# nRF21540

## Revision 2

### Errata

v1.2

Figure 1: Trace code and green sticker on nRF21540 label

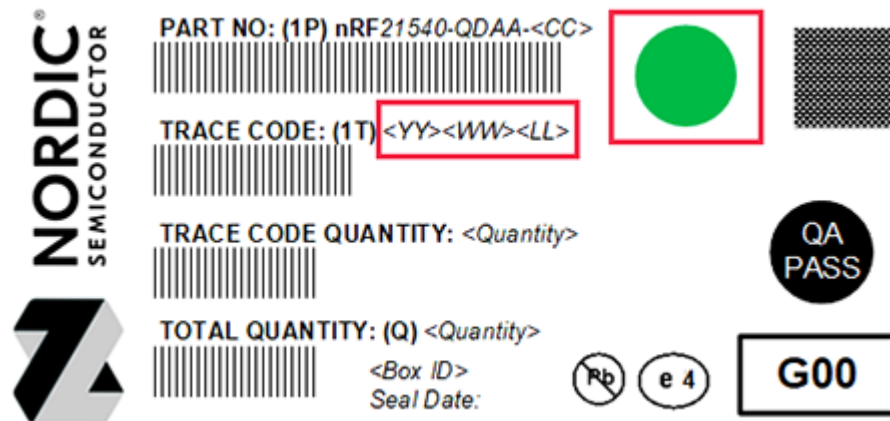
- For trace codes earlier than 2223xx (year 22, week 23), the supply current may be up to several hundred  $\mu$ A in typical conditions. The mean value is expected to be less than 1  $\mu$ A.
- For trace codes earlier than 2223xx (year 22, week 23) with a green sticker on the reel, vacuum bag, and inner box label, the supply current may be up to 1  $\mu$ A in typical conditions. The mean value is expected to be less than 100 nA.
- For trace codes later than 2223xx (year 22, week 23), the supply current may be up to 1  $\mu$ A in typical conditions. The mean value is expected to be less than 100 nA.

Use samples with trace code 2223xx (year 22, week 23) or later or retested samples marked with a green round sticker on the reel, vacuum bag, and inner box label to keep maximum supply current at less than 1  $\mu$ A in typical conditions.
